Modification 7 of Gazcorp Industrial Estate

State Significant Development Modification Assessment Report (SSD-5248-Mod-7)

March 2026

Figure 5 | Proposed GIE Concept Plan

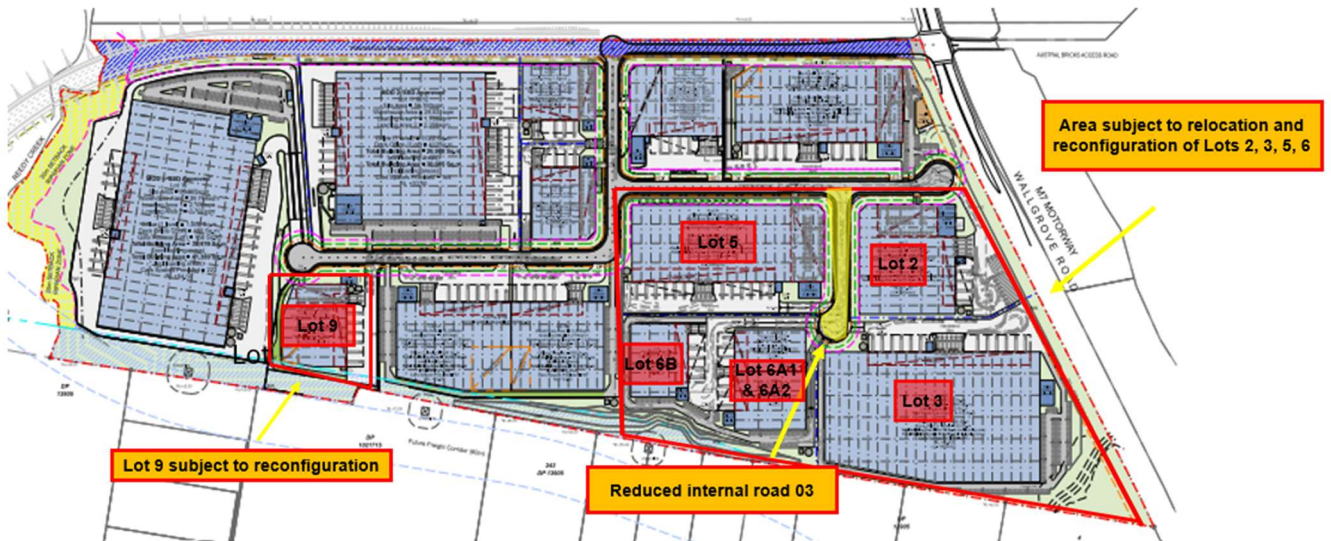
The proposed modification to the Concept Masterplan generally comprise:

- minor adjustment to lots 2, 3 and 9 layout
- reconfiguring lot 6 into lots 5, 6A1, 6A2, and 6B, resulting in an increase in warehouse buildings from 11 to 13 (noting that lots 6A1 and 6A2 are two parts of one warehouse building)
- increase car parking by 26 spaces
- update Condition B22 to include the amended Landscape Masterplan

The proposed modifications to Stage 1 comprise:

- revised cut and fill for new building levels
- updated road layout in eastern sections to access Lots 2, 3, 5, 6A1, 6A2, and 6B
- alterations to Estate Road 03 (reduce length).
